October 6, 2020

**Re: NE Willingboro LLC / The Grand Marketplace  
Short-Term Trailer Storage Facility  
Application for Minor Site Plan Approval,  
Waiver of Formal Site Plan Review, Conditional Use Variance Approval,  
Conditional Use Approval and Bulk Variance Approval  
Block 2, Lot 7.01 / 4340 U.S. Route 130  
Township of Willingboro, Burlington County, New Jersey  
Our File No.: NOR163.001**

Zoning Board of Adjustment Planner Christopher Dochney, P.P., AICP and the Zoning Board of Adjustment Engineer, Bennett Matlack, P.E., CME, CFM correspondence dated September 25, 2020

PROJECT LOCATION: WILLINGBORO GRAND MARKETPLACE  
 BLOCK 2, LOT 7.01  
 WILLINGBORO TOWNSHIP, WASHINGTON COUNTY, NEW JERSEY

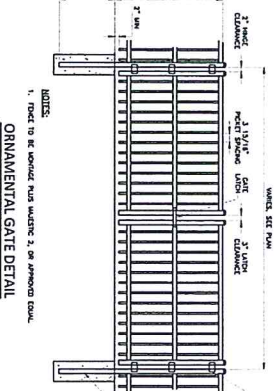
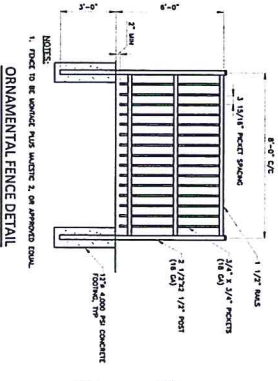
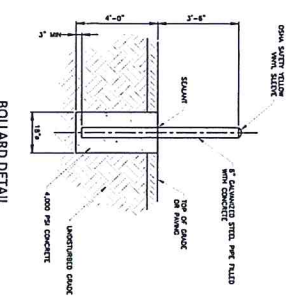
*ii. 155-3.B – fences shall be erected or constructed in the rear or side yard only. A 6' chain link fence is proposed in the front yard of the property.*

- h) **Section 155-3B** – Fences shall be erected/constructed in the rear and/or side yard only; 6 feet chain link fence is proposed within the front yard areas along Route 130 and Sunset Road.

- i) **Section 370-74C(1)** – Wherever the property line of a lot abuts or is across the street from a residential zone, a buffer area shall be established which shall include an area of land 100 feet in width as measured from the property line or street. Minimal landscape plantings are proposed.

6. Existing and proposed buffering/screening and overall site aesthetics should be reviewed with the Board. We note that the Applicant has requested a design waiver regarding buffering requirements and has proposed minimal tree plantings along the Route 130 and Sunset Road site frontages. This represents one of the conditions of the conditional use.

**RESPONSE:** As depicted on the enclosed Plan, Applicant is proposing the installation of decorative aluminum fence the front yard portions of the Property along Route 130 and Sunset Road. Applicant will be prepared to present testimony of its professional planner in support of its request that the Board grant Conditional Use Variance Approval to allow for the front yard fence.

**RESPONSE:** As depicted on the enclosed Plan, Applicant is proposing the installation of decorative aluminum fence the front yard portions of the Property along Route 130 and Sunset Road. Applicant will be prepared to present testimony of its professional planner in support of its request that the Board grant Conditional Use Variance Approval to allow for the front yard fence.

**RESPONSE:** Applicant is proposing landscaping along the frontage of the Property, on Route 130 and Sunset Road, as depicted on the attached Plan.

**RESPONSE:** Applicant will be prepared to provide testimony of its professional engineer regarding the proposed landscaping depicted on the enclosed Plan. Applicant will agree, as a condition of the Board's Approval, to revise its plans to further enhance the proposed landscaping.
